90-AA-1 ISLAND AVE. PEAKS ISLAND
90-J-3 to 8

Island Ave., corner of Brimmer R/W
Peaks Island

Nov. 30, 1971

Typical Frame Openings

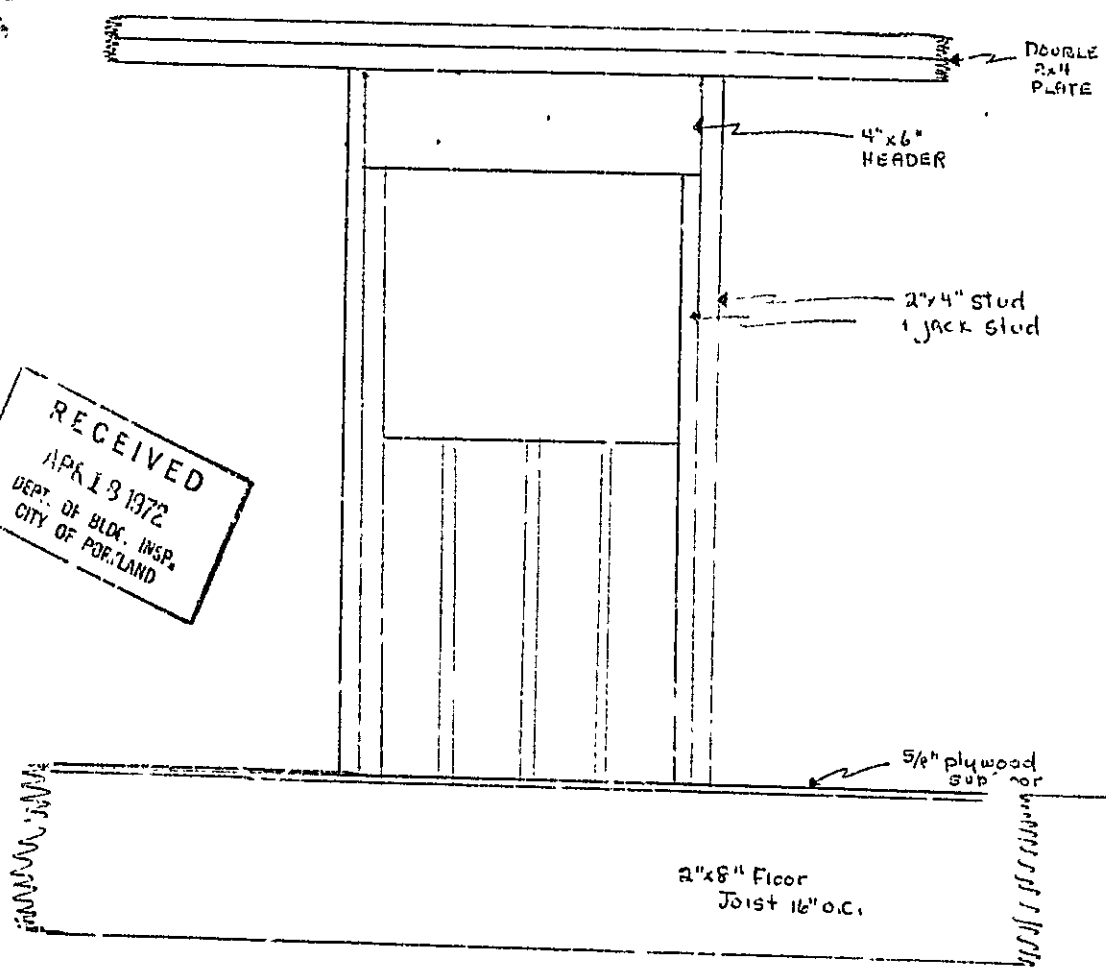
4. Anchor bolts for sills shall be located at each corner and not more than 6 feet from center to center between corners. (Section 1503.2.7)
5. ^{4" x 6" ceiling} We will need to know what the headers will be over the window on the front on a span of about 7' 3" and the door in the rear which is a span of 6' 10". We will also need a floor plan showing the location of bedroom, kitchen, etc. so that we can check the arrangement against Building Code requirements.

3. I will use the correct size and method for the sills and also will comply with the code concerning
4. the anchor bolts listed in question 4.
5. As you can see by the new set of plans, the front window and the rear door, have been reduced in size. The headers for these openings as well as all carrying headers in the plan will be 4 x 6's.

HERCULES TRUSS PLATES
 4 TO 12 TRUSS

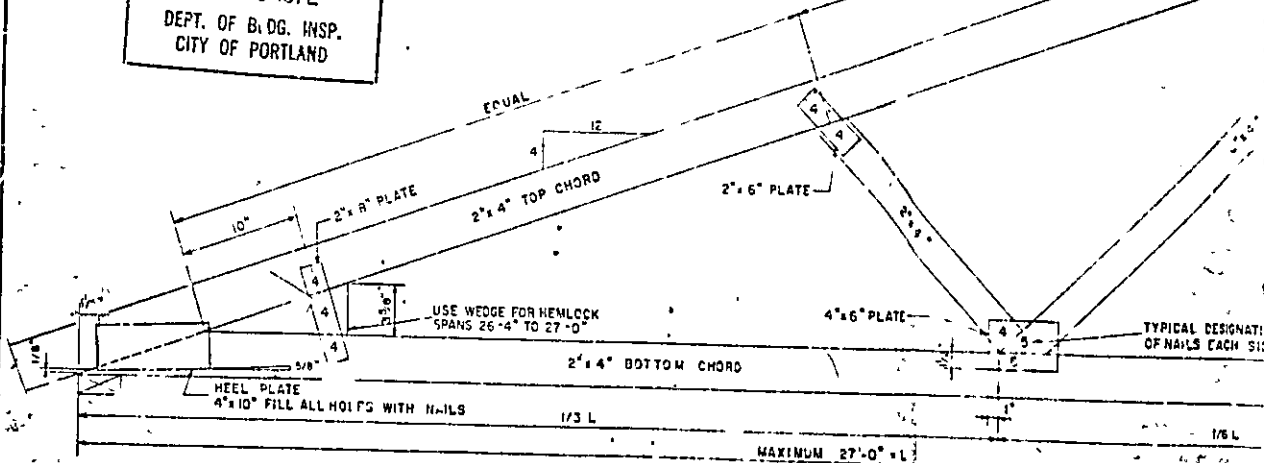
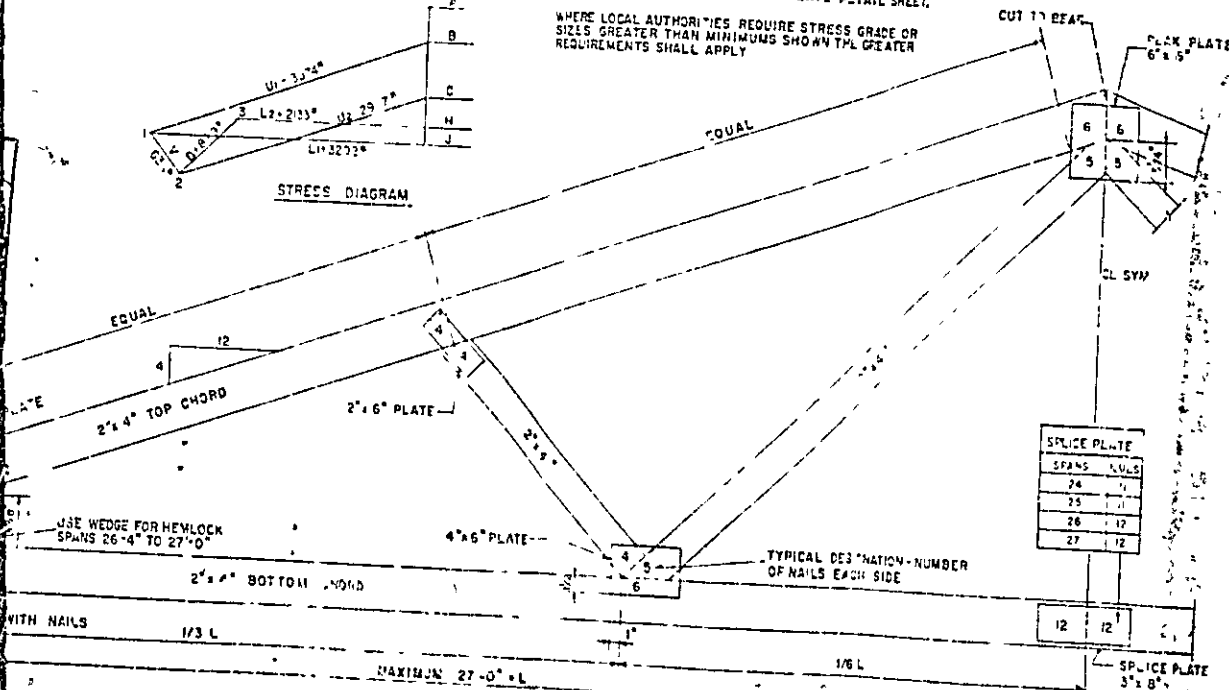
Oh 11. We will need to know who is to supply the trussed roof rafters for this building. If we do not have these on file here at this office then we will need to have supplied to us by a competent designer, information and calculation showing that these trusses will support the load that these will be put to for this part of the country.

This is to acknowledge your letter of January 10th and planned information of the truss you propose to use on your building at the above named location. We have checked this out and find it adequate to meet our roof loads in this area.

Typical Exterior Views

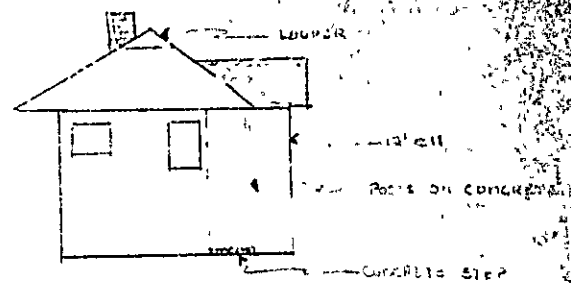
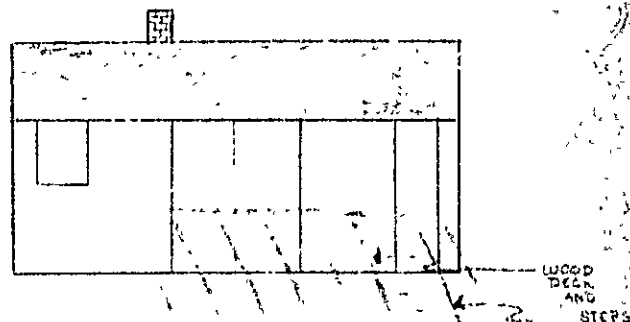
10. There is also a discrepancy on your elevation plan. You show the left side view with an outside port resting on a concrete step or slab which would seem to indicate you plan some kind of porch in this area, however, the other three elevations and your floor plans of your building do not show this therefore I will need some information.

10. The new plan has a corrected version of the exterior views of the proposed building. If any further explanation is needed, please contact me. There will not be an outside post or porch on the front of the building.

First Floor Plan

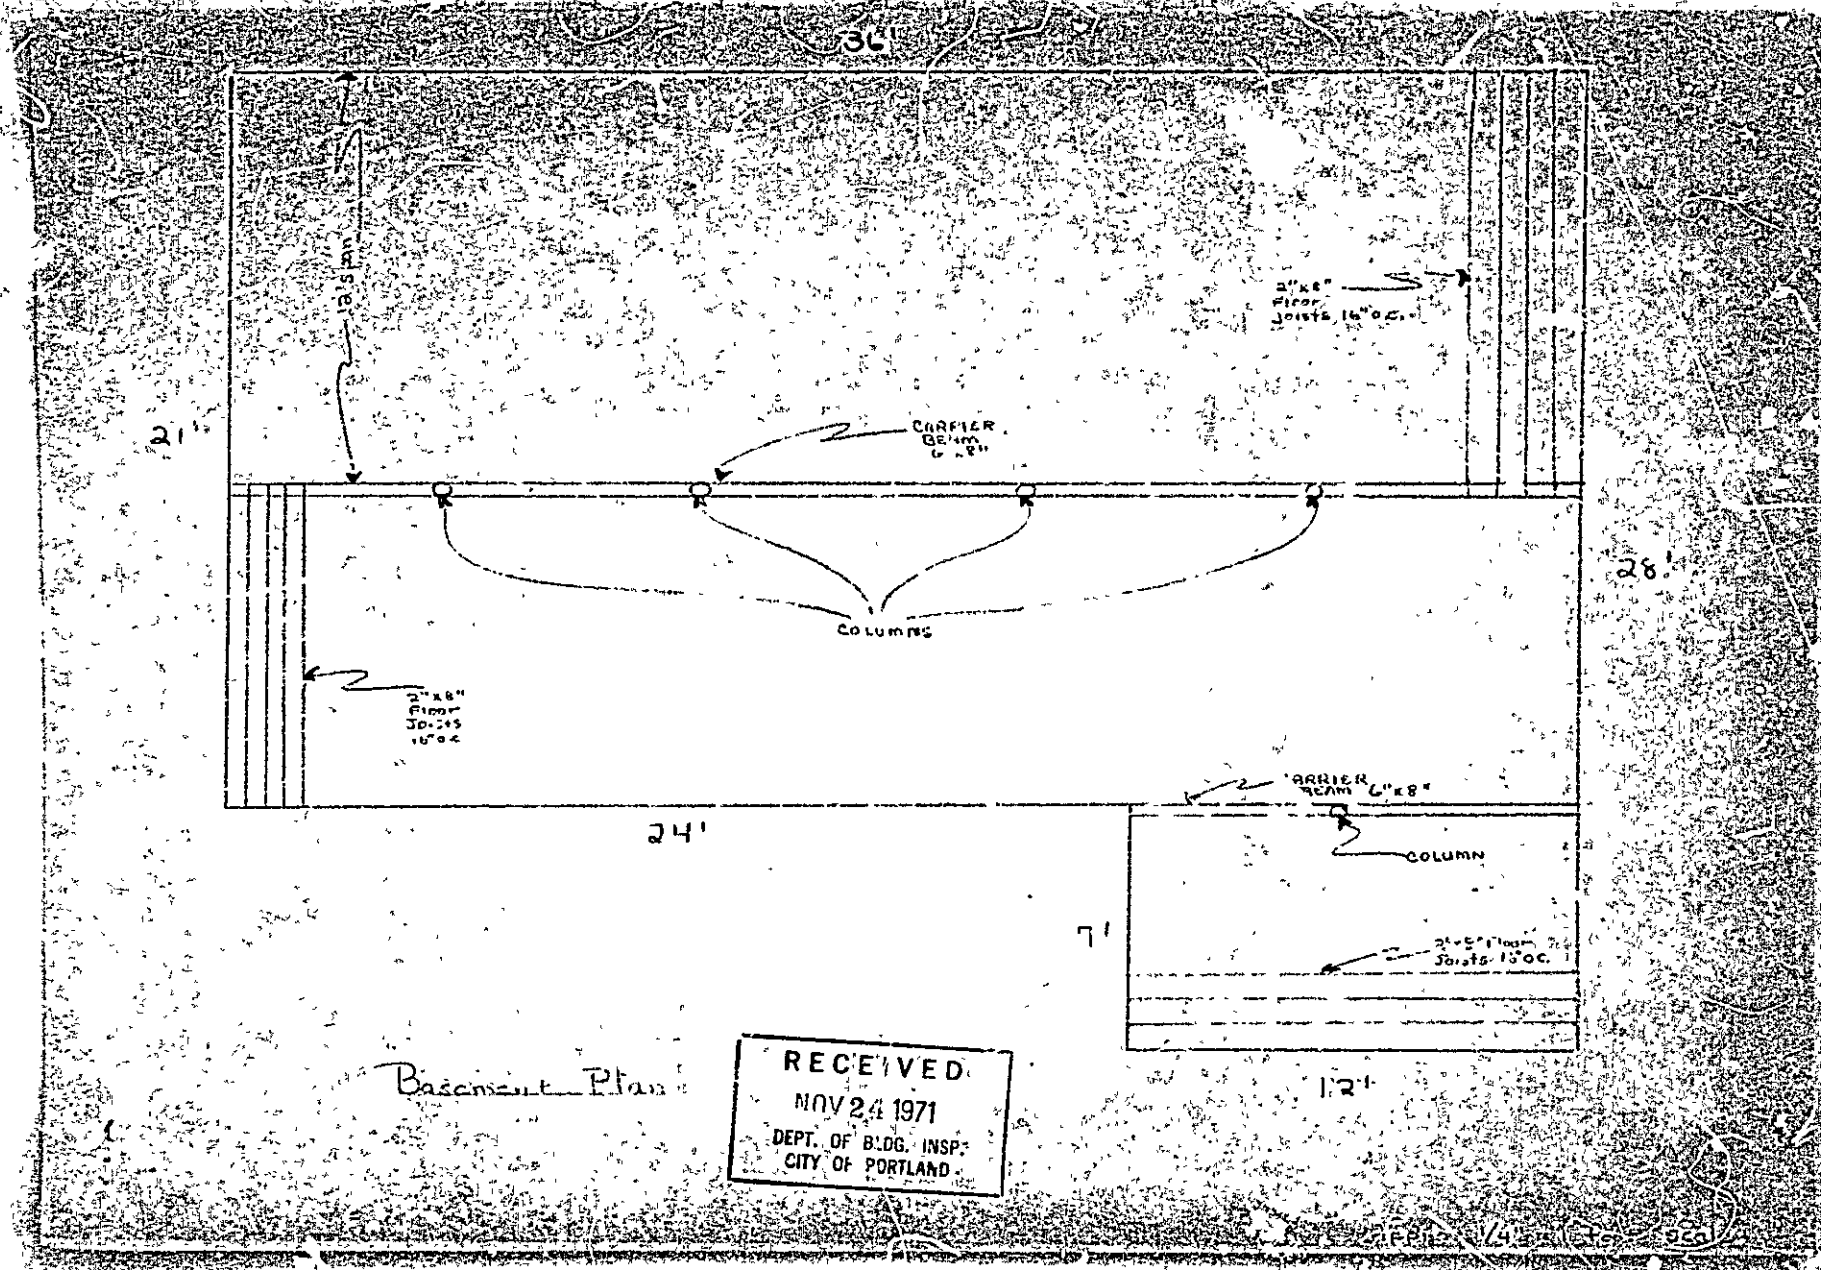
9. I have one set of plans showing the planning of the first floor in which the main carrying beam goes down through the center of the building supported by four columns, which I would assume would be evenly spaced about 7 feet on centers. I also have another plan showing a series of carrying beams which is altogether different than the first. This will need to be clarified before we can check your framing.

I have figured this girder (6x8) down to the center of the building as being located 7 feet on centers. ?

9. Due to an error in drawing and labeling the previous set of plans the carrying beams were incorreced represented. I am sure the new plans will be self-explanatory.

REAR-DECK-
LOCATION-AND-REIN-STAR-
TO-GRADE-AND-CONSTRUCTION

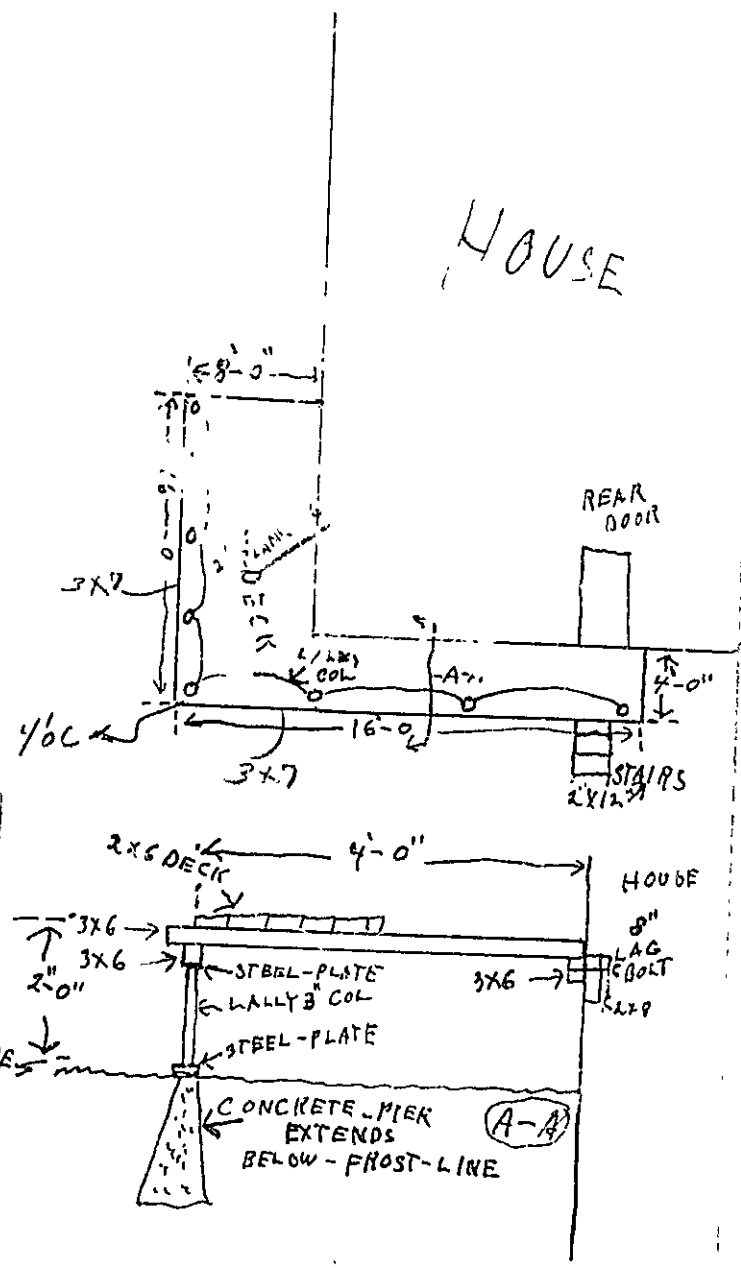
1. The size of the foundation piers for the rear porch deck
is not given. These concrete piers will need to be not
less than 9 inches in diameter if round and at least 8 inches
in cross section if square. These piers are to extend at
least four feet below grade or to ledge.

2. The columns supporting the rear porch construction above
these piers may be three inch pipe or not less than 3/4 inch
lally columns.
3. The sills will need to be at least solid 4x6 inch members
rather than the 3x6 inch members shown.

4. It appears that you propose to support the rear porch plank
deck on 3x6 inch members laid flat and spanning between
the house and pier sills. This method is questionable as
the plank would have more strength in spanning this distance
than would the 3x6 inch flatwise member supporting the
plank deck.

**CHIMNEY-LOCATION
 AND
 CONSTRUCTION**
**WENDELL
 WRIGHT**

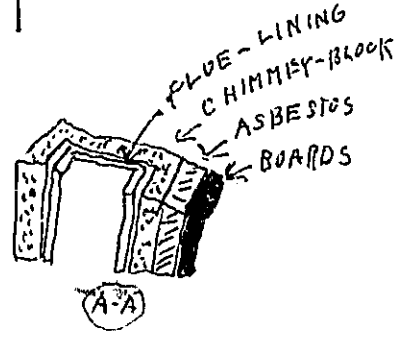
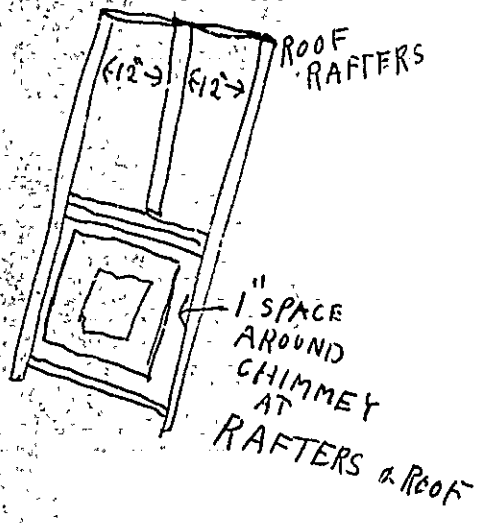
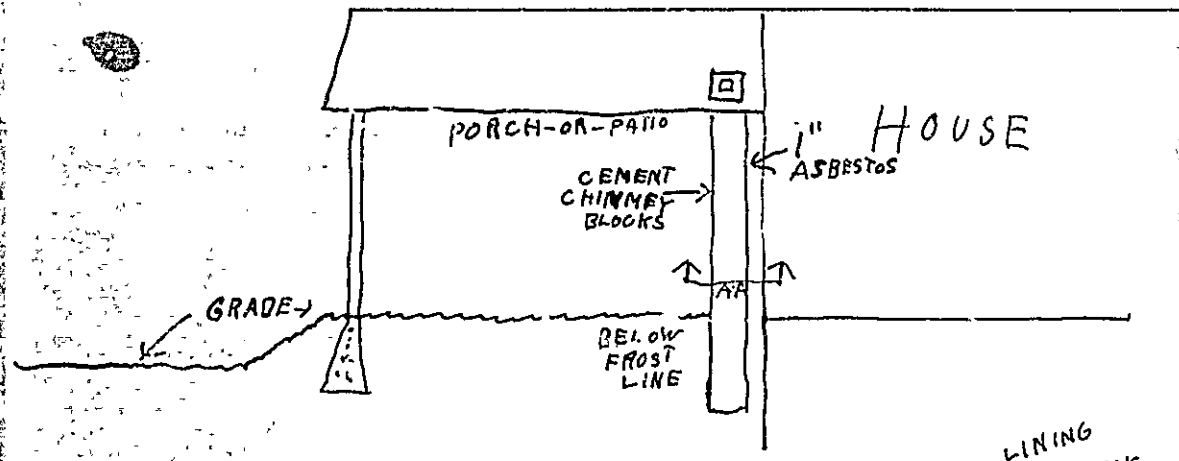
5. This is no indication on your drawing as to the size of the
foundation for the chimney. Also this chimney will need to
extend at least two feet higher than the roof where it pierces
the roof and at least as high as any portion of the roof.

In reply to your letter of
May 10th the size of the
foundation for the chimney is
1 foot thick, 4 ft sq. and
4 1/2 ft in the ground.
